Important Notices

Restrictions on the Voltage Detection Circuit

Datasheet Corrections: Electrical Characteristics of the Power-On Reset Circuit

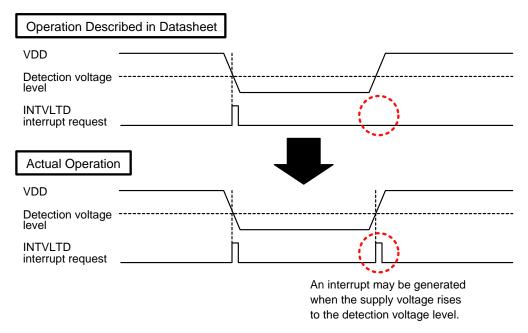
1. INTVLTD Interrupt Request

When interrupt generation is enabled in the voltage detection circuit, an INTVLTD interrupt request may be generated not only when the supply voltage falls to the detection voltage level, but also when it rises to the detection voltage level.

In ICE mode of the In-Circuit Emulator (TMP89C900), no interrupt request is generated when the supply voltage rises to the detection voltage level. Therefore, with products supporting the In-Circuit Emulator (TMP89C900), the interrupt generation operation may differ between the development tool and the actual product.

2. Releasing STOP Mode by Voltage Detection

The SRSS bit in the voltage detection control register 2 (VDCR2) provided for releasing STOP mode by voltage detection cannot be used because it does not function as expected.

Do not use the INTVLTD interrupt for voltage detection. The voltage level should be regularly checked using other timing such as the execution cycle of the main program. VDCR1<VDxSF> (x=1, 2) can be used to check the voltage level. However, if the operating voltage is near the detection voltage, the VDCR1<VDxSF> value may become unstable. It is recommended that VDCR1<VDxSF> be tested multiple times to determine the voltage level.

Always set VDCR2<SRSS> to "00". Use the STOP pin to release STOP mode.
